APPENDIX A

NEVADA BART REGULATION

FEDERAL LAND MANAGEMENT AGENCY COMMENTS AND NEVADA'S RESPONSE

Federal Land Management Agency Comments and Nevada's Response, April 17, 2009

JARBIDGE WILDERNESS AREA with 15 MILE BUFFER and LAND STATUS

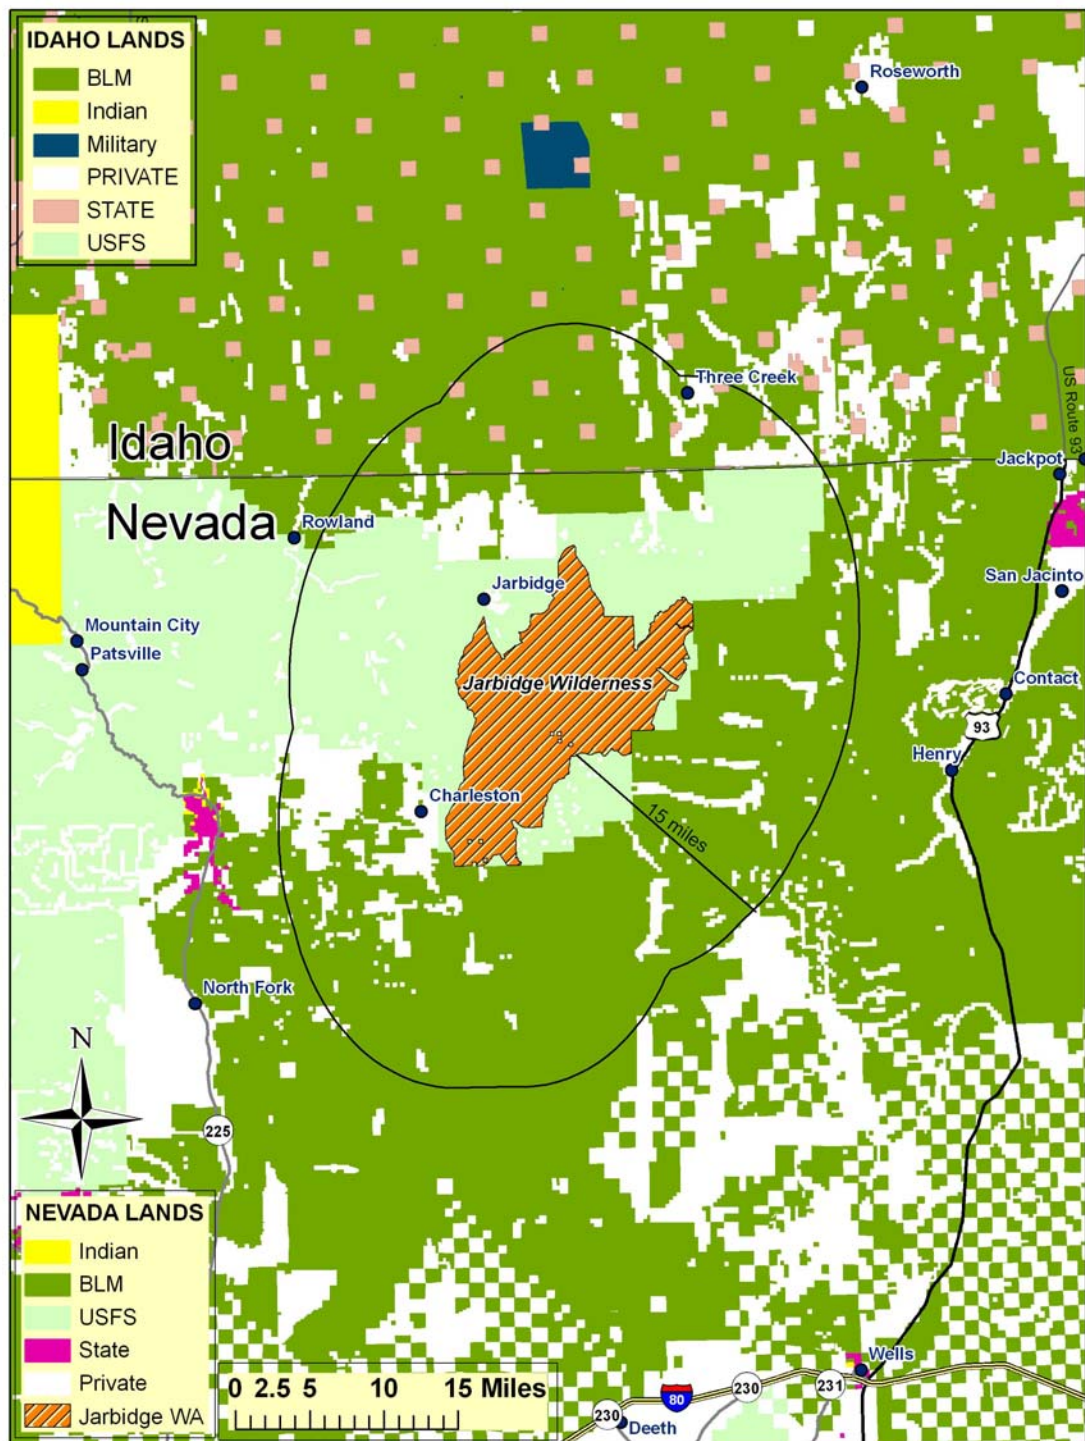
Attachment to Comment 28 (FS) response:

**FIGURE 1. ALTERNATIVE LEAST COST ENVELOPES FOR
REID GARDNER UNITS 1, 2 AND 3***

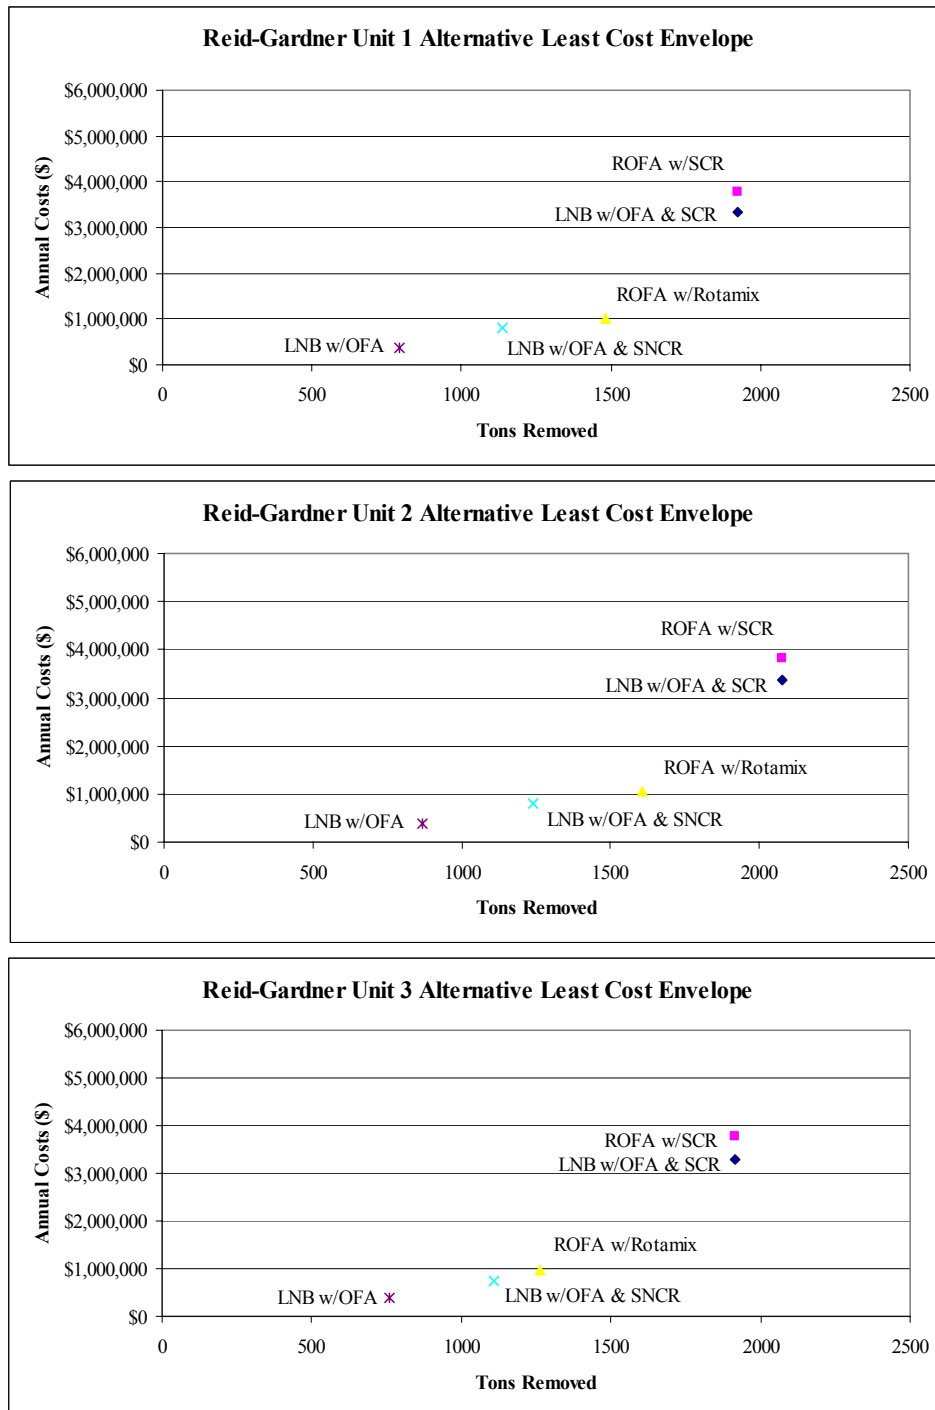
Examination of Table 2 and Figure 1, below, shows the results of NDEP's alternative cost analyses do not change our determination of BART for the three Reid Gardner units, even with

*NOTE: Revised using lower NV Energy control efficiencies in lb/MMBtu and NV Energy annual costs reduced by 30 percent.

Figure 1. Source Apportionment Results for Grand Canyon.

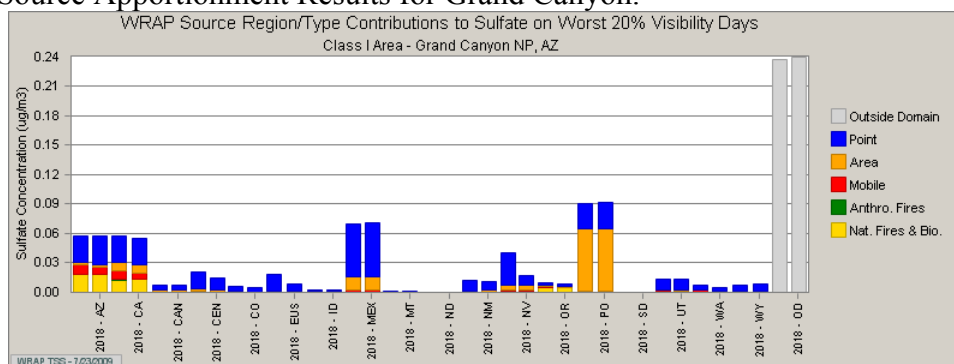
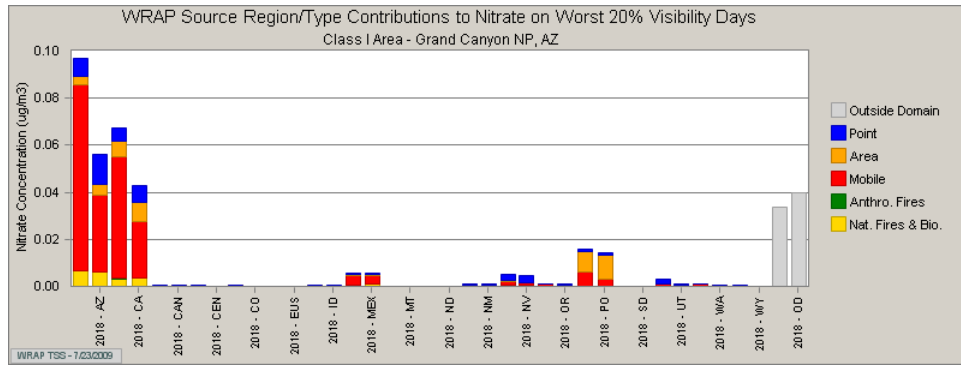
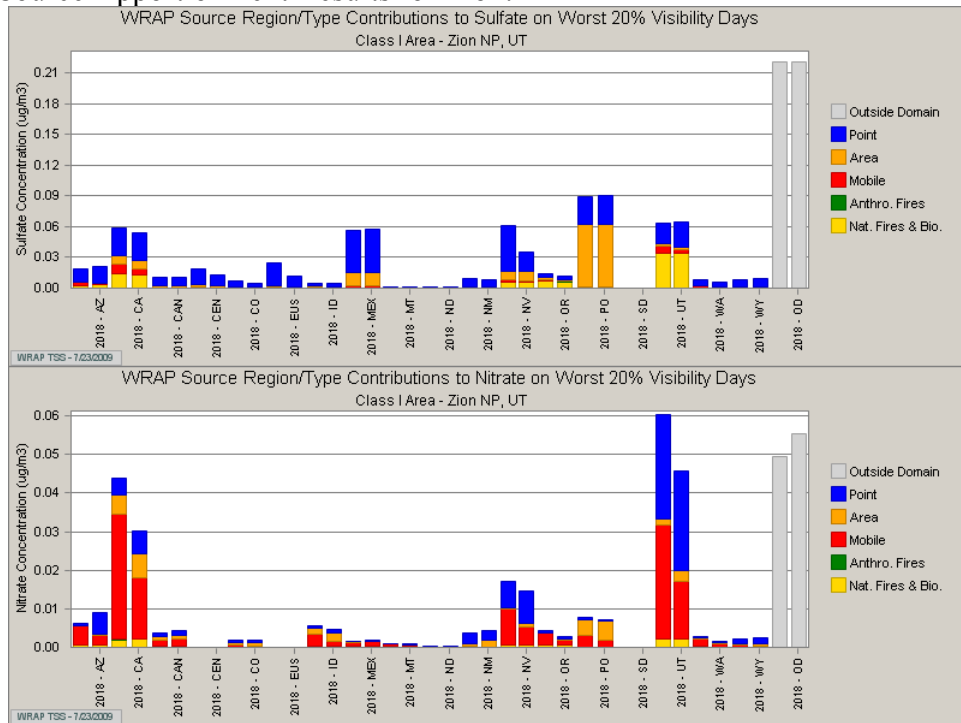
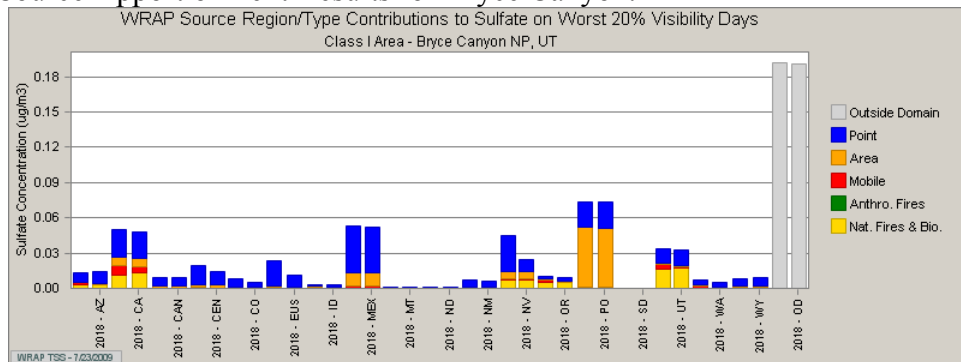
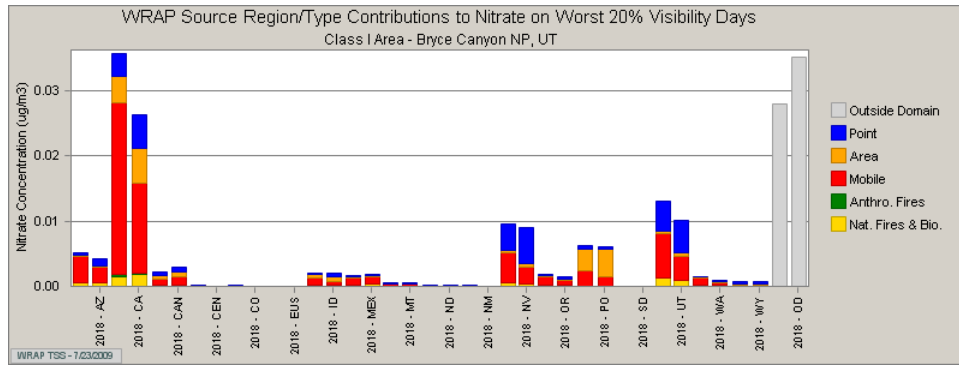
Figures 1, 2 and 3 present the worst days sulfate (top image) and nitrate (bottom image) 2002 baseline (plan02c emissions inventory) and 2018 projected (base18b emissions inventory) source apportionment modeling results for Grand Canyon, Zion, and Bryce Canyon, respectively.

Figures 1, 2 and 3 show the relative contributions to visibility impairment as paired bars for each state or source area, the first for the baseline and the second for 2018. These figures also show the relative reduction in contribution by each source area from the baseline to 2018.

These figures show that modeling results for these three Class I areas fail to meet the uniform rate of progress glide slope for nitrate and sulfate, except nitrate at Grand Canyon. 2018 sulfate consistently falls approximately 0.5 Mm^{-1} (0.44 to 0.48 Mm^{-1}) short of the URP glide slope for all three areas. Nitrate falls short 0.20 and 0.79 Mm^{-1} at Bryce Canyon and Zion, respectively. However, 2018 nitrate progress at Grand Canyon exceeds the URP glide slope.

No changes were made to the RH SIP as a result of this comment.
